EXPRESS GROUP PTY LTD

UPDATED TRAFFIC REPORT FOR
LEP AMENDMENT TO INCLUDE
TRUCK FACILITIES AT
194 CAMPBELLTOWN ROAD,
DENHAM COURT

AUGUST 2020

REF: 10909/3

26.0m B-DOUBLE VEHICLE
SWEPT PATHS

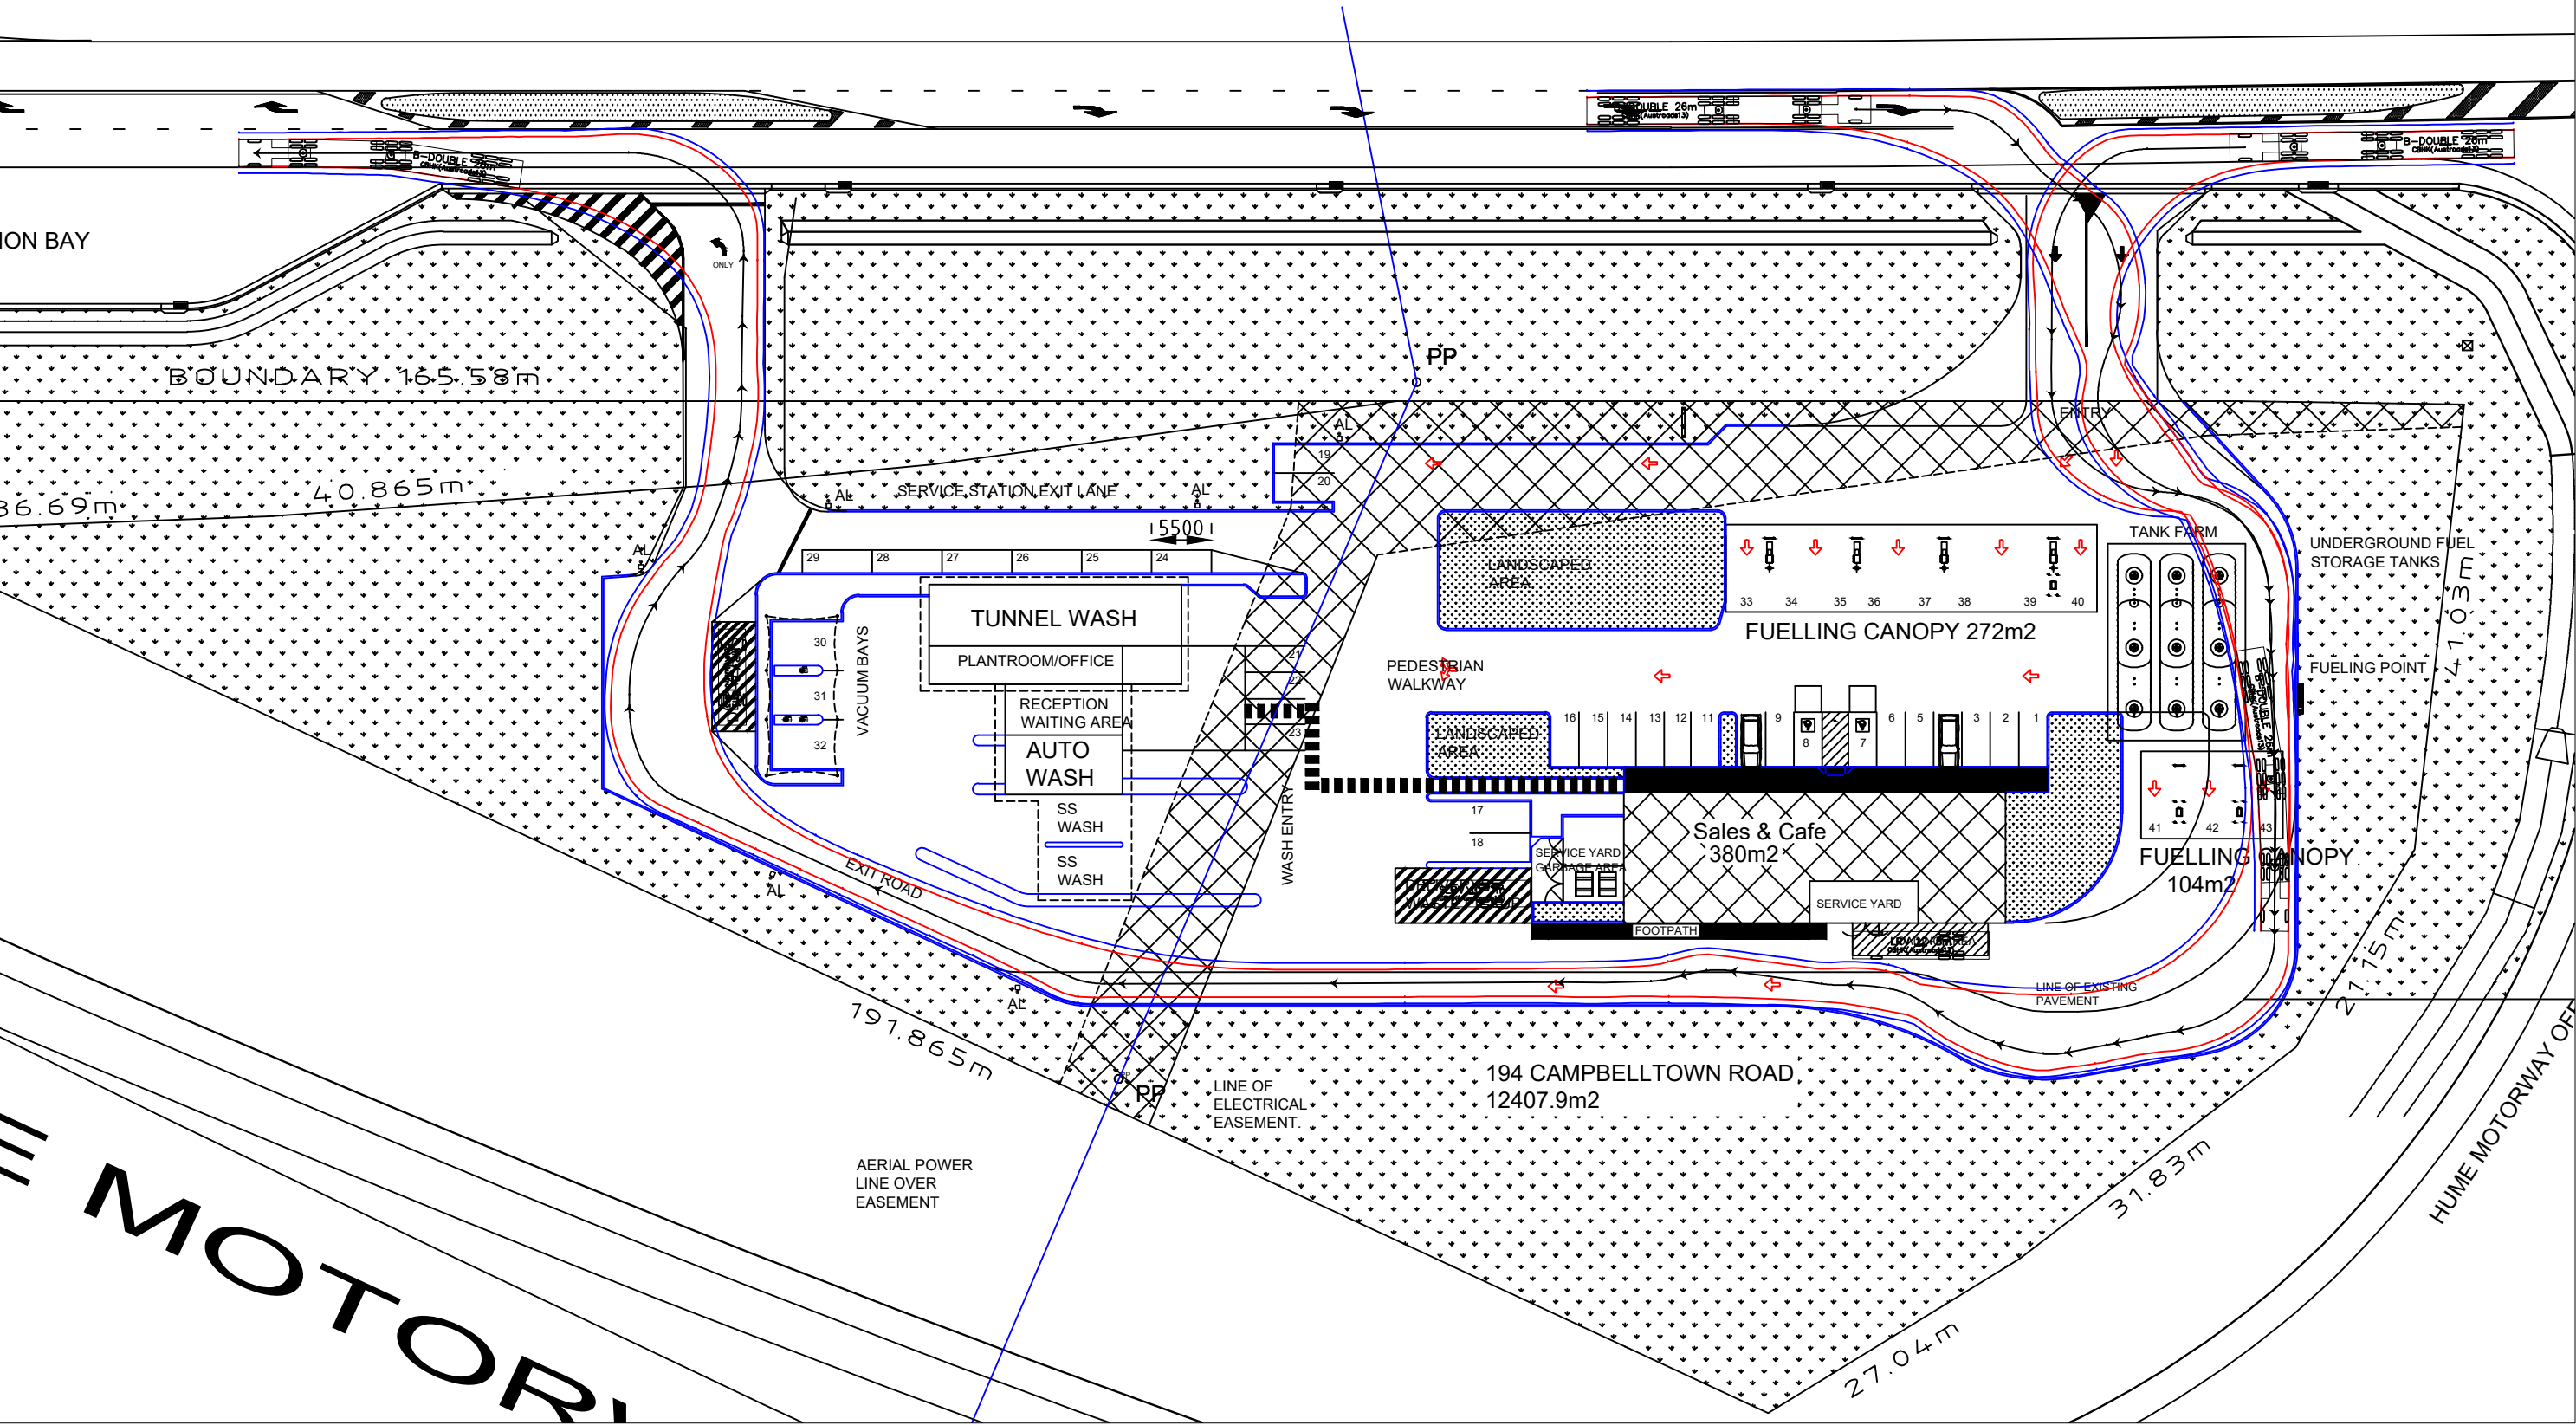
- (e) *Update the supporting Traffic Report to address the suitability of the proposed long vehicle movements and access and egress arrangements;*

- Assessment of compliance of design vehicle swept paths to/from the subject site, as well as manoeuvrability with the site, to Australian Standards
- Adequate storage of vehicles queuing to access the fuelling points without impacting the network operation of Campbelltown Road
- Impact of design vehicle entering the site on the operational performance on the intersection of Campbelltown Road/Hume Highway off-load ramp.
- Design of driveways to accommodate the design vehicle.

I.7 The approved right turn bay in Campbelltown Road has been designed to accommodate the turning movements of trucks, including to allow petrol delivery tankers to access the site. Swept paths showing 26 metre b-doubles entering and exiting the site with the approved right turn bay and proposed driveways are shown in Figure I.

26.0m B-DOUBLE VEHICLE
SWEPT PATHS

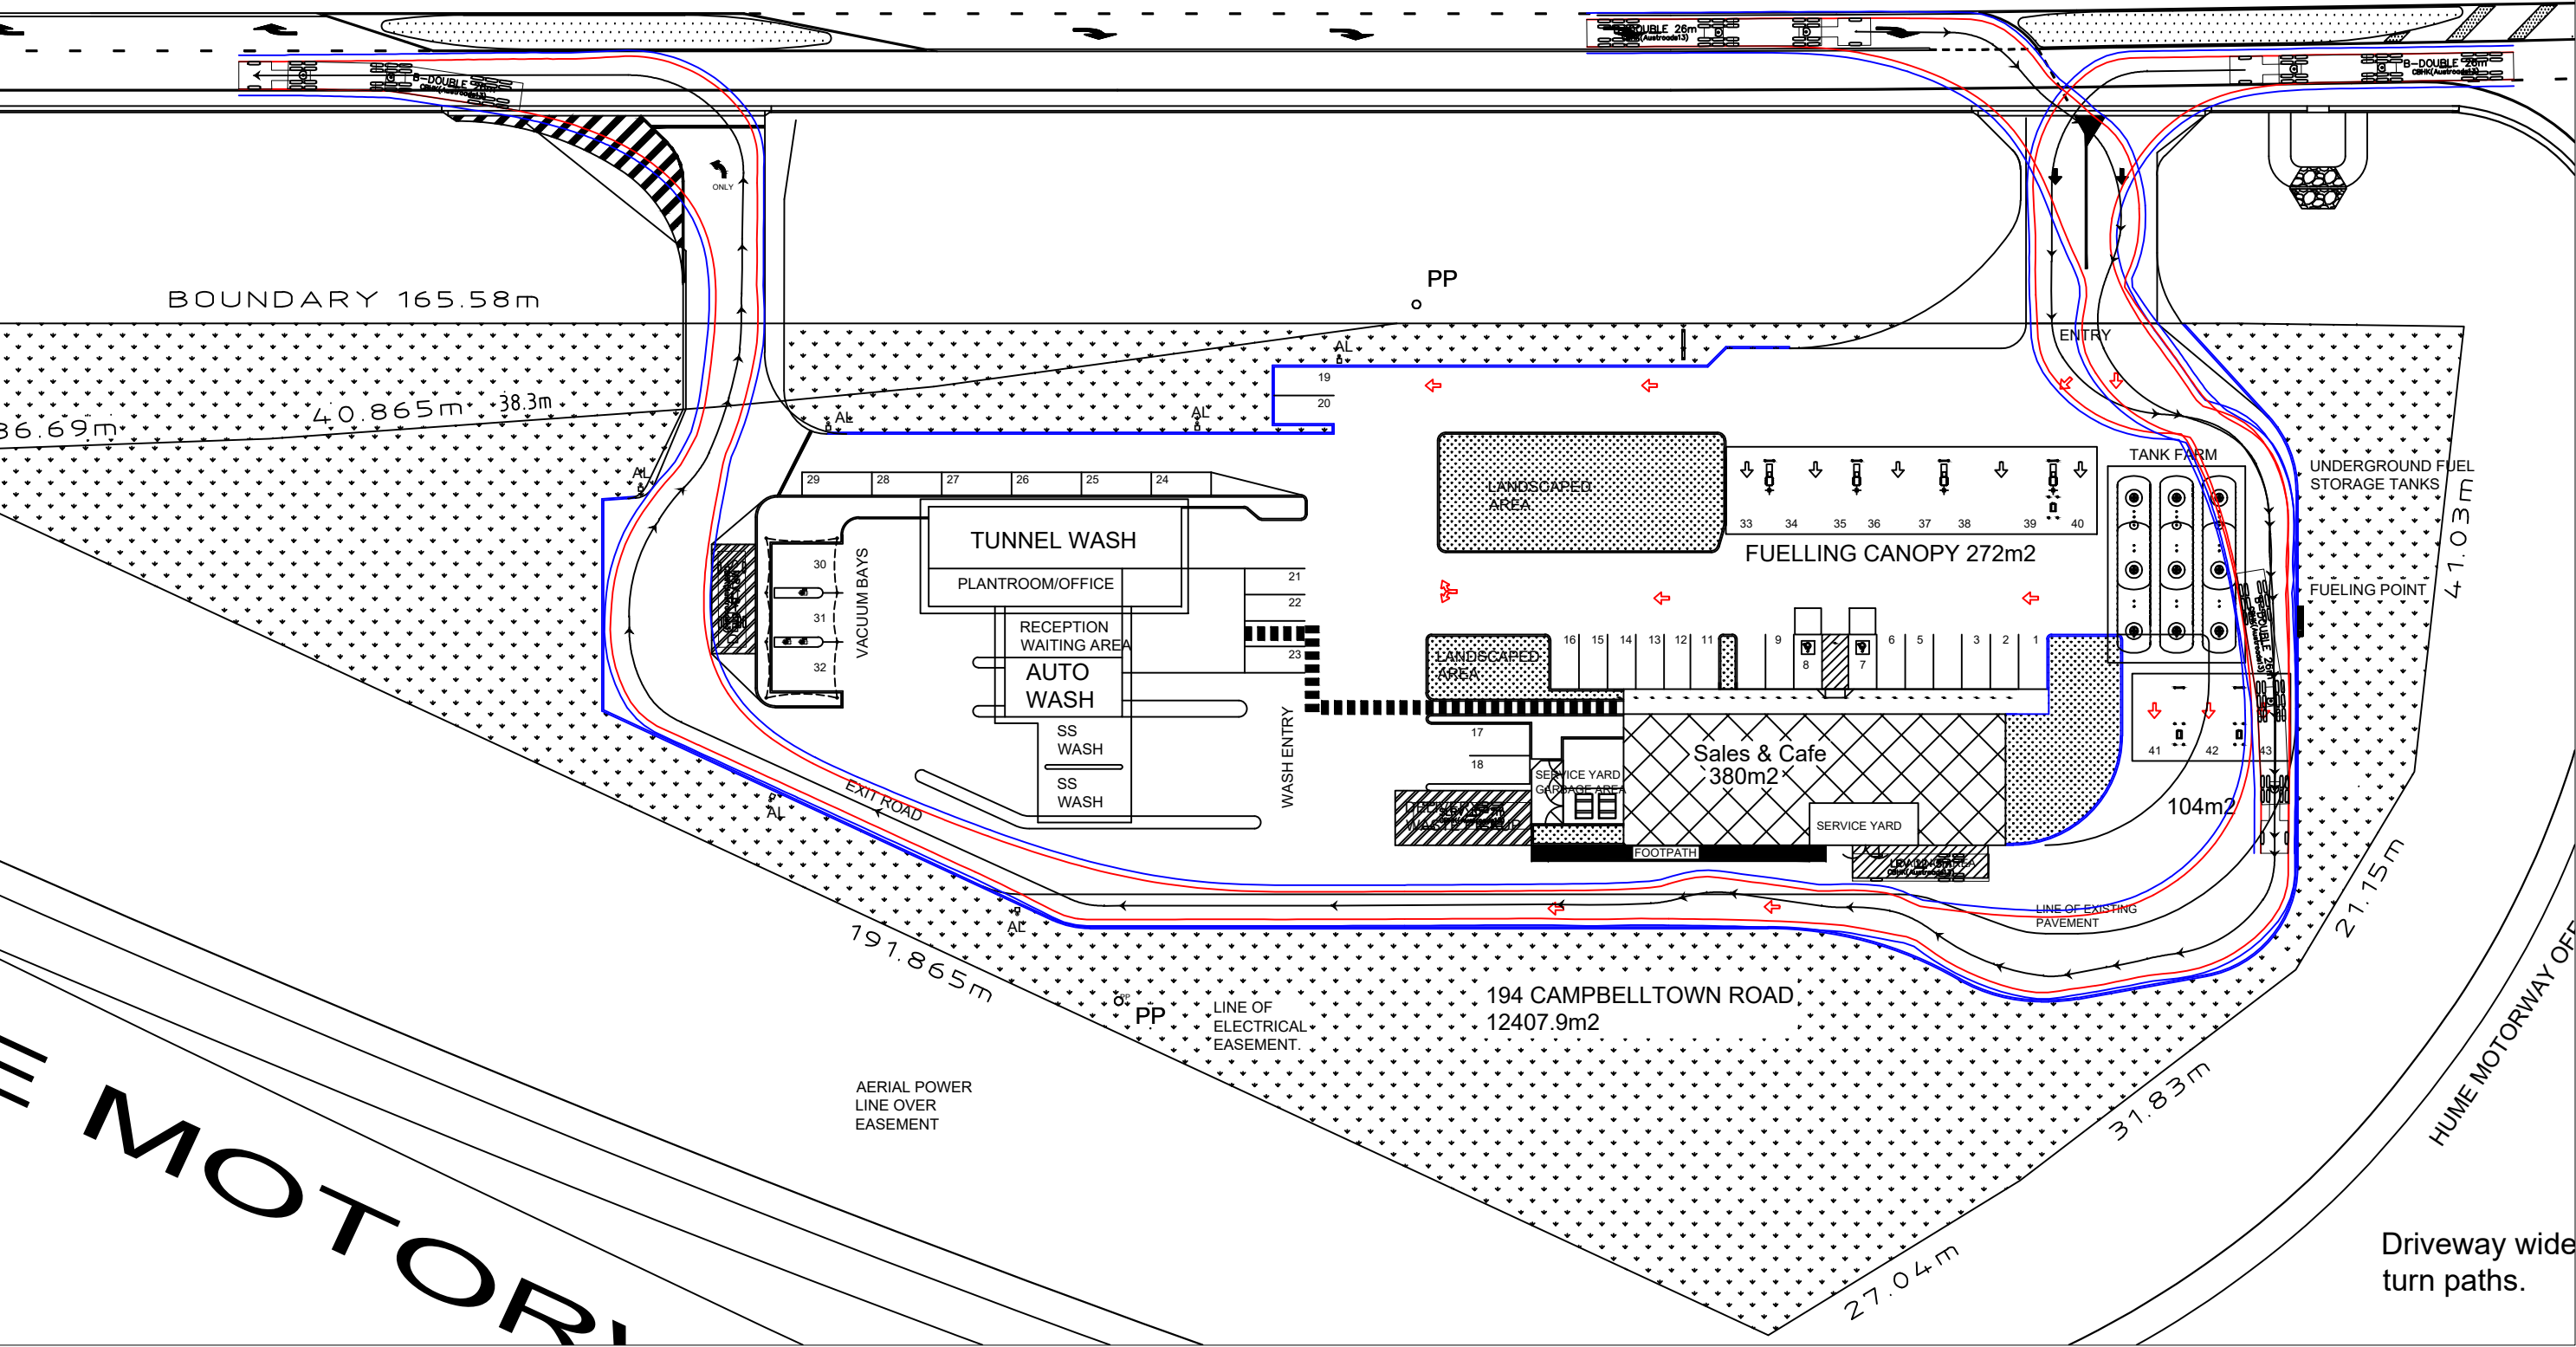
- 2.29 The matters raised by the RMS, for assessment as part of the development application, and noted by the panel, are discussed below.
- *Assessment of compliance of design vehicle swept paths to/from the subject site, as well as manoeuvrability with the site, to Australian Standards.*
-

2.30 These matters are discussed in paragraphs 2.7 and 2.8. Vehicle swept paths are shown in Figure 2.

PETROL QUEUING

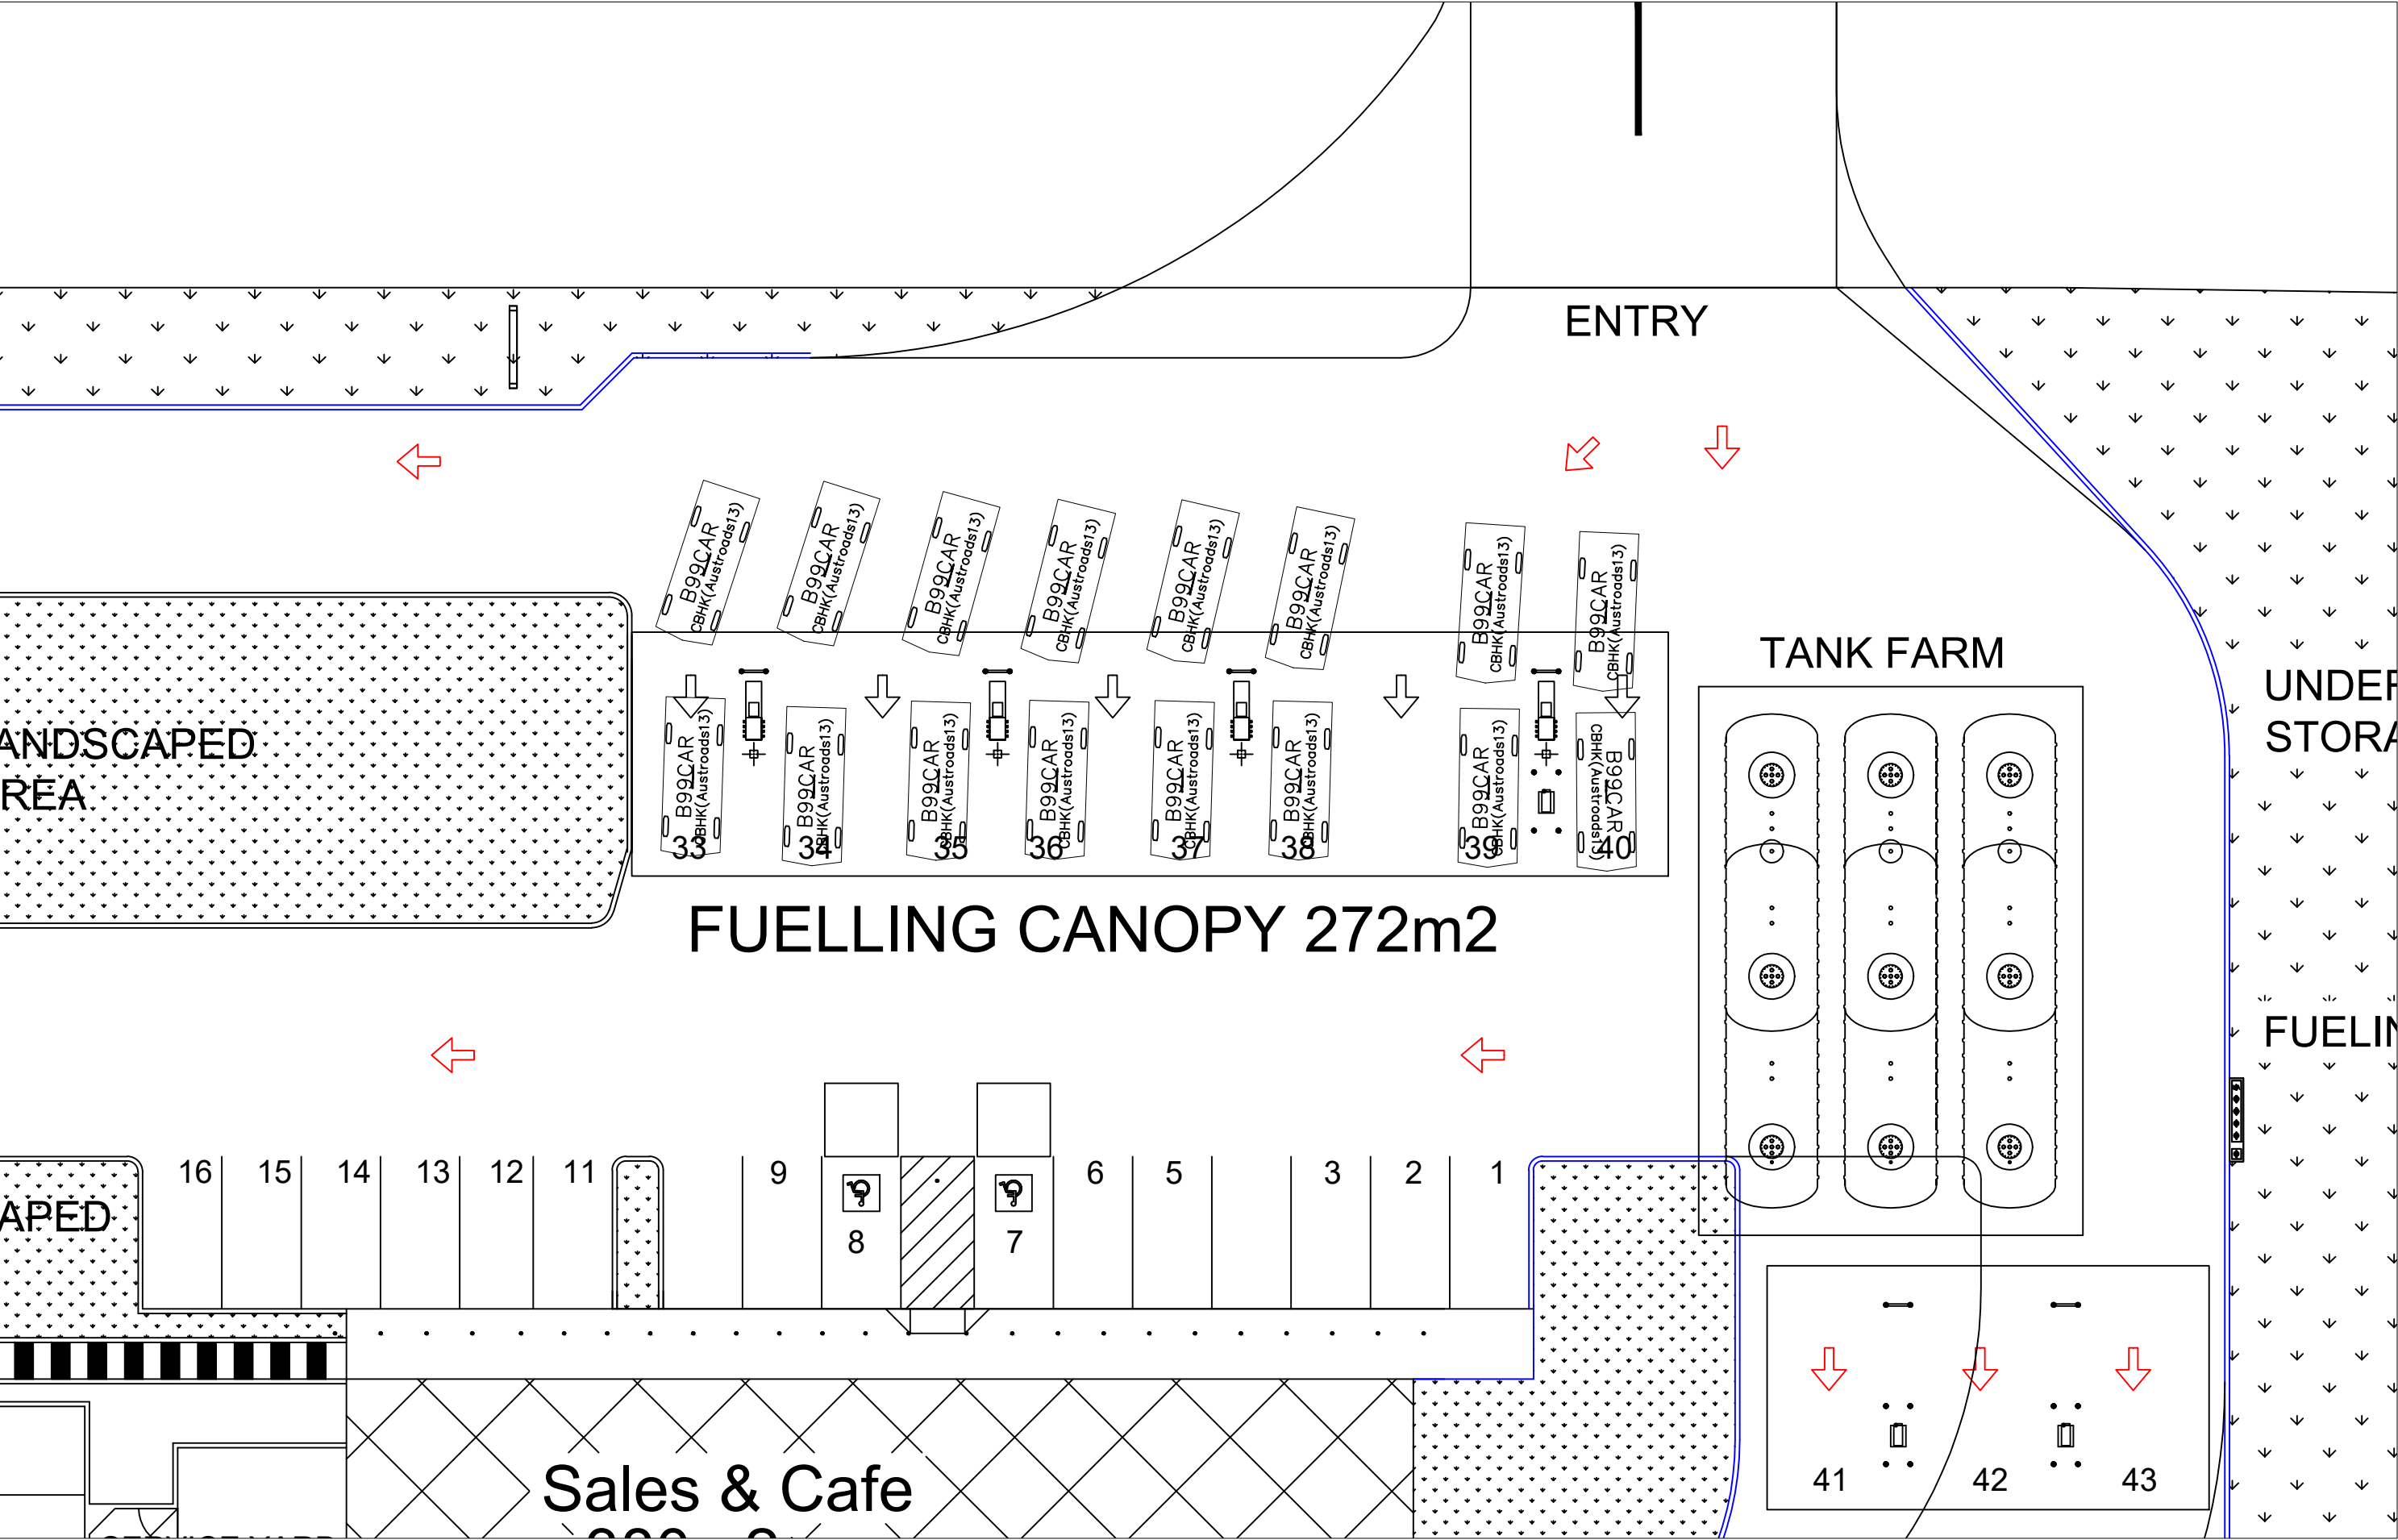
- *Adequate storage of vehicles queuing to access the fuelling points without impacting the network operation of Campbelltown Road.*

2.31 This matter is addressed in paragraphs 2.9 and 2.10.
